# Program Bulletin

## CUSTOMER SATISFACTION PROGRAM

**SUBJECT:** Air Conditioning System Inoperative or Cools Intermittently

**MODELS:** 2013-2014 Chevrolet Spark

**A/C Refrigerant Filter Kit**

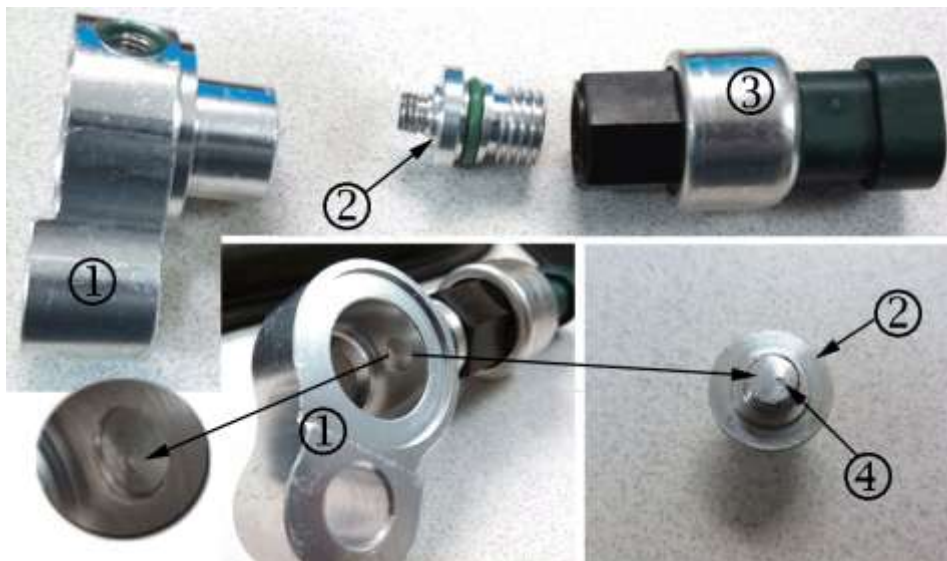
**The A/C refrigerant filter kit photograph and kit description have been revised. Please discard all copies of bulletin 13434B.**

(1) Block Filter (2) Plug with 0.005 in Diameter Hole (3) Pressure Switch (4) 0.005 in Diameter Hole

**Note: Do NOT attempt to drill the 0.005 in diameter hole bigger.**
